CITY OF ALBUQUERQUE

RE: LHM Hyundai - 9820 Coors Blvd NW
Grading Plan and Drainage Report
Engineer's Stamp Date: 02/04/2019
Hydrology File: B14D017

Based upon the information provided in your submittal received 2/12/2019, the Grading and Drainage Plan cannot be approved for Grading Permit or Paving Permit until the following comments are addressed.

Grading/Drainage Plan
LHM Hyundai Coors Boulevard
9820 Coors Blvd NW
Albuquerque, New Mexico

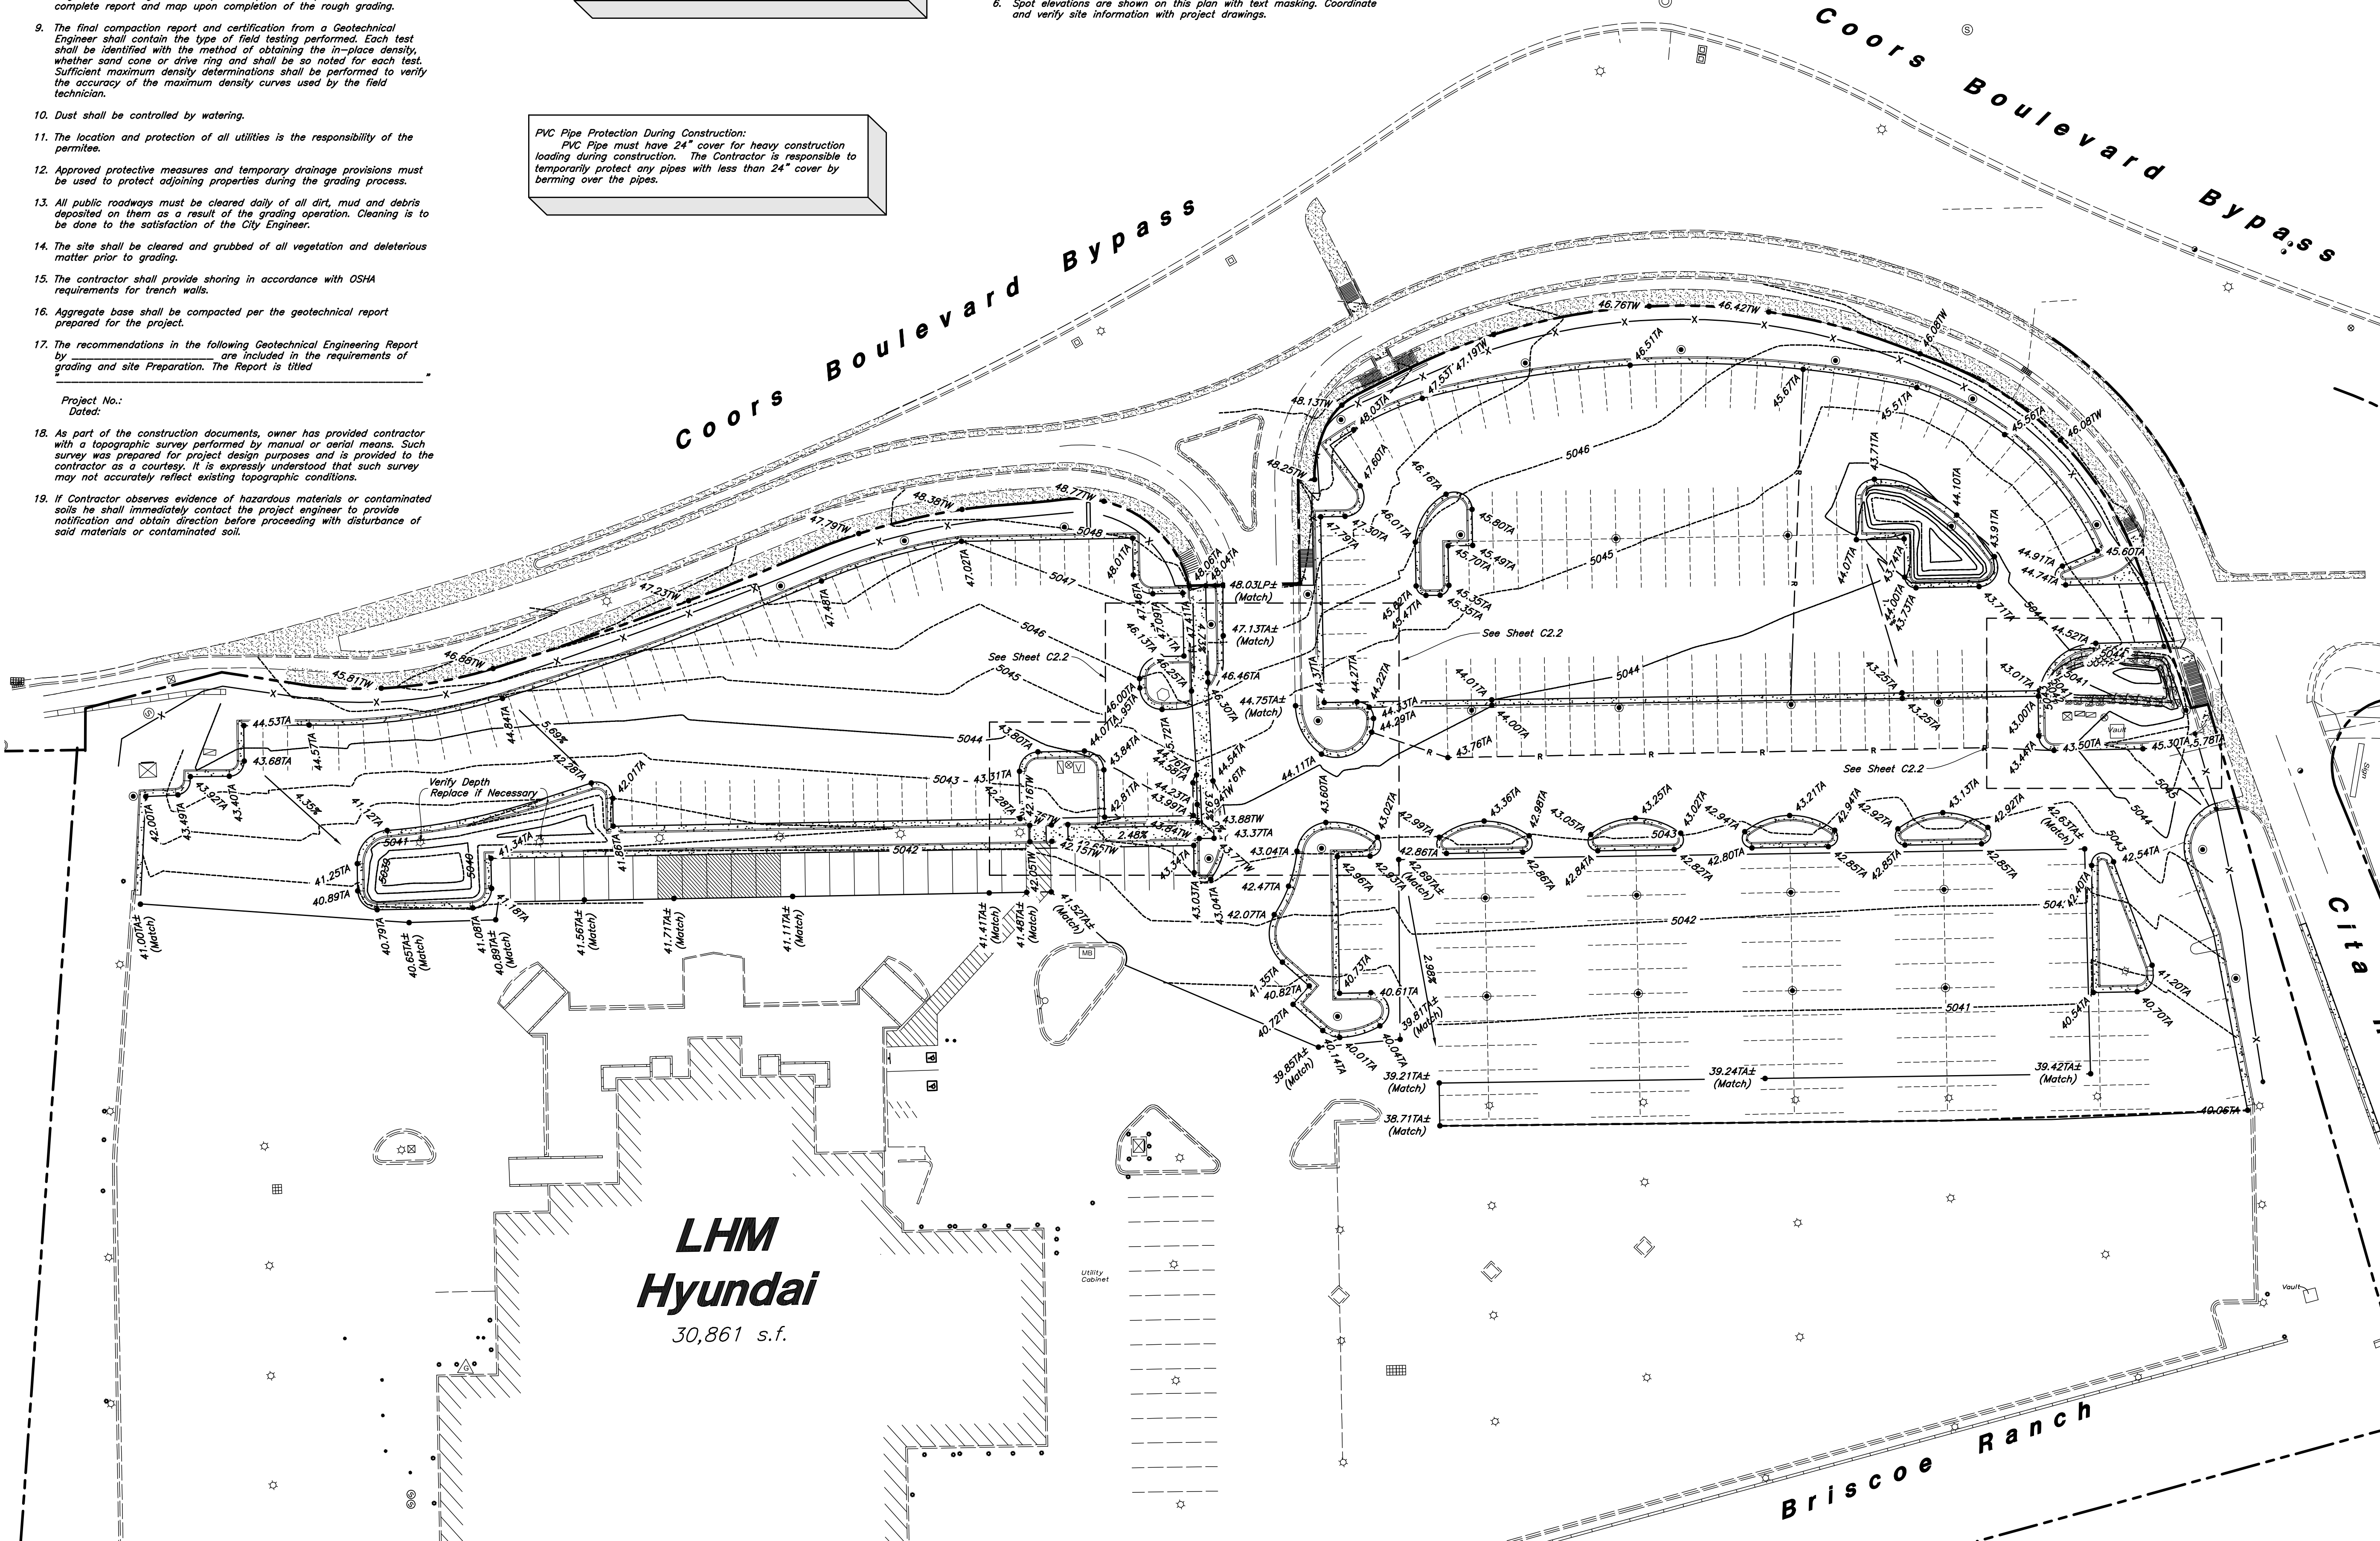
1. An Engineer's stamp and signature are required on all engineering calculations including the G&D Plan and the Drainage Report.
2. The lot line between the City and County should be clearly identified on the G&D Plan. A note should be added identifying the different jurisdictions and separate approvals are required for construction in each:

3. A drainage narrative needs to be added to the G&D Plan. It should describe the two different Drainage Management Plans for the City and the County
 - a. The City Drainage Management Plan is to provide the required Stormwater Quality Volume (SWQV) in onsite Best Management Practice (BMP) ponds and to freely discharge the peak 100 year flow rate into the existing storm drains constructed during earlier phases of this development in the adjacent Public ROWs west and south of the City portion of this site. None of the runoff from Tract B-1 Lands of Black Development is allowed into the County. The legal description of the City portion of this site is Tract B-1.

4. Please label the Stormwater Quality Volume (SWQV) required, the SWQV provided, the BMP elevation, and the 100 Year elevation on the plan view of each BMP Pond.

- a. Basins boundaries need to be shown on the G&D Plan around the area draining to each BMP, and the BMP should be sized for the required SWQV of the area draining to it.

- b. Credit in excess of the required SWQV for the area draining to each BMP is not allowed. Additional BMPs may be required for 100% site coverage or the owner may elect "Payment in lieu" of construction of the required SWQV.

- c. The 100 year elevation of each BMP pond should be far enough below the top of dam elevation to allow freeboard for construction tolerances and settlement.

- d. The crest elevation of the overflow spillway should be set far enough above the required BMP elevation to allow freeboard for construction tolerances and settlement.

- e. Calculations are required for the overflow spillway from each BMP pond to determine the 100 year elevation and to demonstrate the adequacy of the pond outfall structures.

- g. Please provide details of the pond outfall structures.
5. Please show the existing and proposed storm drain pipes on the G&D Plan and on the plan view details of the ponds. Differentiate between existing and proposed. Include profiles of the new pipes showing Q and V. Please provide HGL calculations following the DPM procedures applying minor losses to the EGL using Bernoulli's and show the EGL in the calculations. If any of the planned storm drain construction is in any public right of way then an approved Work Order will be required.

7. Previously approved plans do not account for any part of Tract B-1 drainage to go east into Bernalillo County. Please correct the grading and drainage plan to insure compliance with the previously approved plan.
8. A written approval from the City Transportation Development Services must be provided either approving a Traffic Circulation Layout (TCL) or a waiver of the TCL requirement.
